CASE:	UDP-S24057
MEETING DATE:	October 22, 2024
REQUEST:	Site Plan Level IV Review: Public Purpose Use for 45,953 Square-Foot Community Recreation Facility and 12,951 Square-Foot Emergency Clinic with Associated Parking Reduction
APPLICANT:	City of Fort Lauderdale
AGENT:	Andrew Schein, Lochrie and Chakas, P.A.
PROJECT NAME:	YMCA/Broward Health at Holiday Park
PROPERTY ADDRESS:	840 N. Federal Highway
ZONING DISTRICT:	Boulevard Business (B-1) and Parks Recreation and Open Space (P)
LAND USE:	Commercial and Park and Open Space
COMMISSION DISTRICT:	2 – Steven Glassman
NEIGHBORHOOD ASSOCIATION:	Victoria Park Civic Association
CASE PLANNER:	Lorraine Tappen

Case Number: UDP-S24057

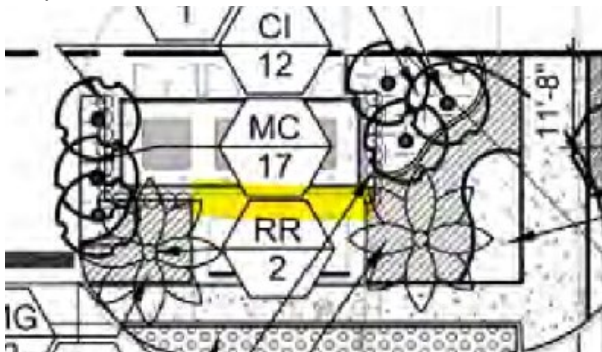
9. Sight triangles located at the intersection of a local street or driveway with a right-of-way under County, State or Federal jurisdiction, may be subject to the sight visibility requirements of those jurisdictions, as per ULDR 47-2.2. Q. Illustrate such sight triangles and provide documentation that application for approval has been made for planting in such right-of-way area.

- a. Approval from jurisdiction for landscape installation in Right Of Way, preferred prior to final DRC sign off. If jurisdiction approval is obtained after DRC final sign off and the plans require any change, Administrative Review will be required prior to permit review.

RESPONSE: Sight Visibility Triangle will not apply to this project as the intersection of NE 8th Street and Federal Highway is a lighted intersection.
